Waterway Management Consultants

24 December 2010

RE: RIVERWOOD RETIREMENT VILLAGE
9 CANNING STREET AVONDALE HEIGHTS
UPDATE REPORT ON FLOODPLAIN MODIFICATIONS

Figure 1 (Sheet 2 of 2)

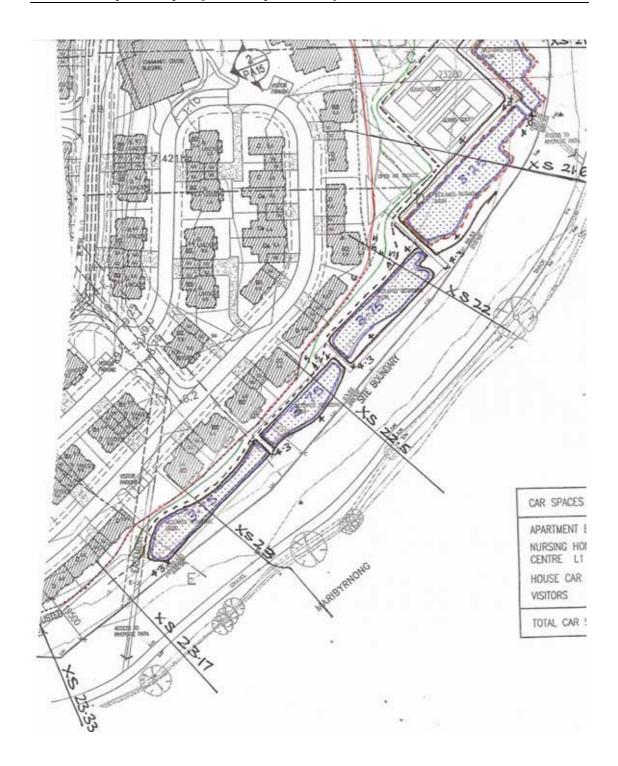
You will recall that MWC have previously indicated approval-in-principle to the floodplain development proposals dating back to 4 November 2005 in letter to The Planning Group dated 23 November 2005 (MW Ref 2782). That development plan is attached as Figure 1 (Sheets 1 and 2) for ease of reference and to also show the location of floodplain cross-sections used in the HEC-RAS hydraulic model.

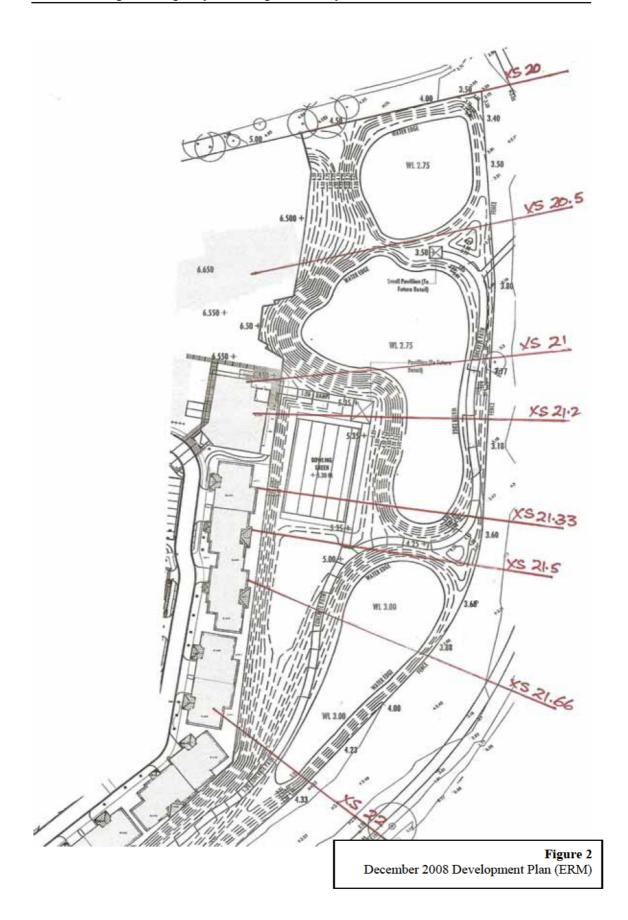
The floodplain modification plan included in the report of 4 December 2008 is attached as Figure 2. The plan extended only to cross-section 22 as no other changes were proposed upstream of this point compared with the 2007 version.

Figure 4 (Sheet 2 of 3) Riverwood Floodplain Grading Plan, Dec 2010 (ERM)

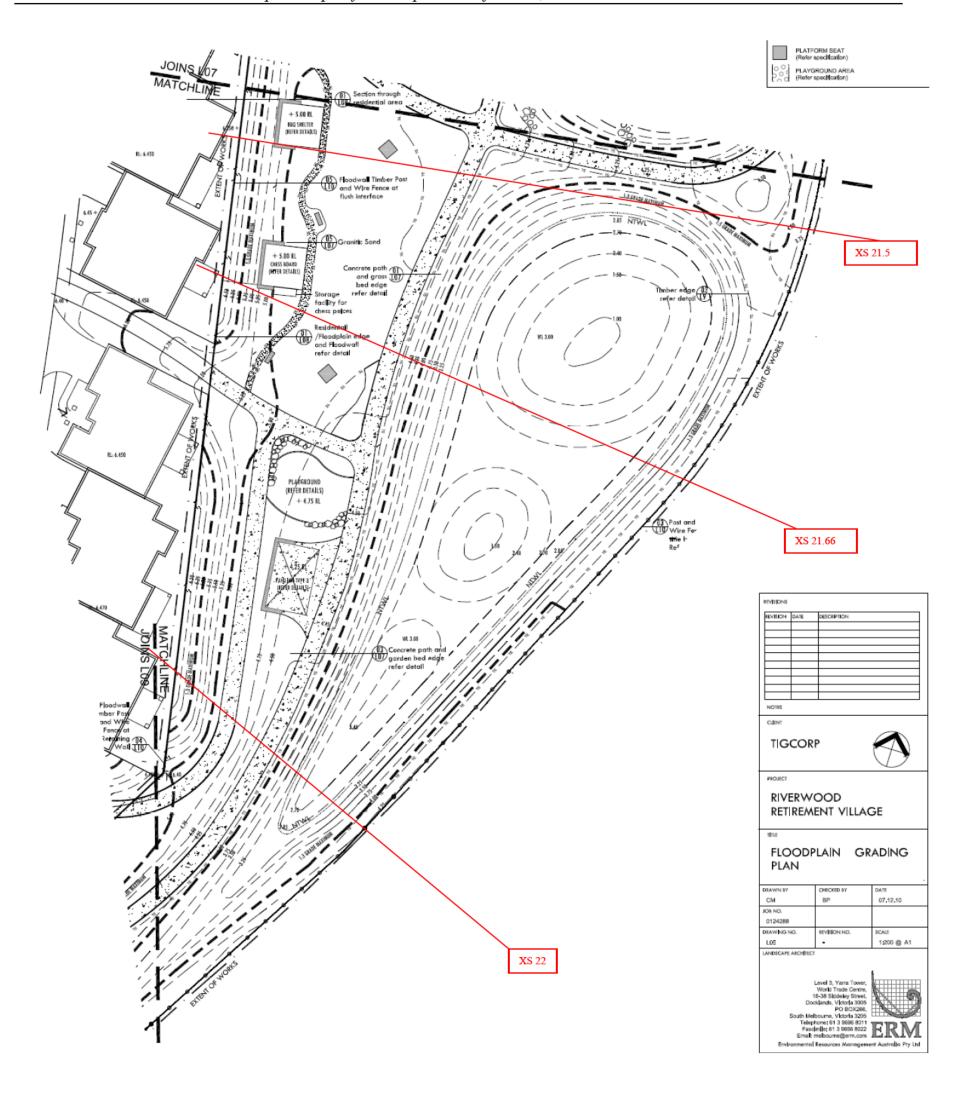
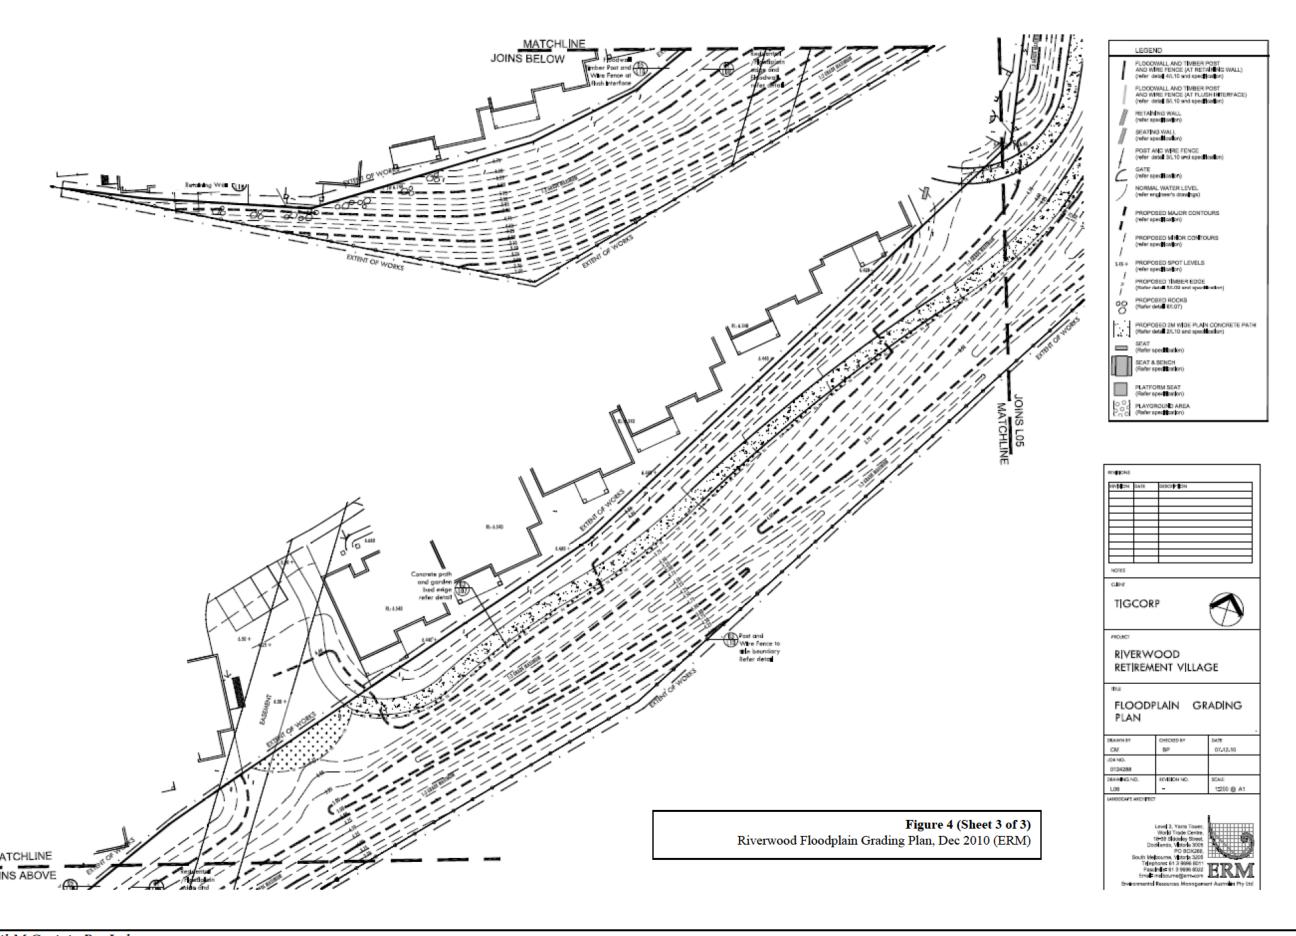
The new December 2010 floodplain landscape concept plan for Riverwood is attached as Figure 3 and the detail floodplain grading plan as Figure 4 (Sheets 1-3).

The latest design differs from the December 2008 plan only in regard to minor changes to the northern wetland area and the bowling greens:

- the bowling green site has been converted to passive green space and has been lowered by 0.5 m to increase floodplain storage and reduce intrusion into the floodplain area;
- the wetland pool originally located in the lee (north) of the former bowling green has been reduced in size to straighten the development boundary, ease batter slopes and eliminate significant retaining walls;
- no changes apply at or upstream of XS 21.5, and downstream of XS 21.

Detailed quantities of floodplain storage have been taken out by WBCM P/L using a digital terrain model derived from the floodplain grading plan shown on Figure 4 (Sheets 1-3). The DTM has verified that compared with the December 2008 proposal, the current design increases floodplain storage volume by 3,840 m³.

<u>It is now requested</u> that MWC confirm that the final December 2010 floodplain modifications as shown on Figures 3 and 4:

- still comply with MWC and best practice requirements, and
- are approved in principle, subject to submission of detail plans in the usual way.
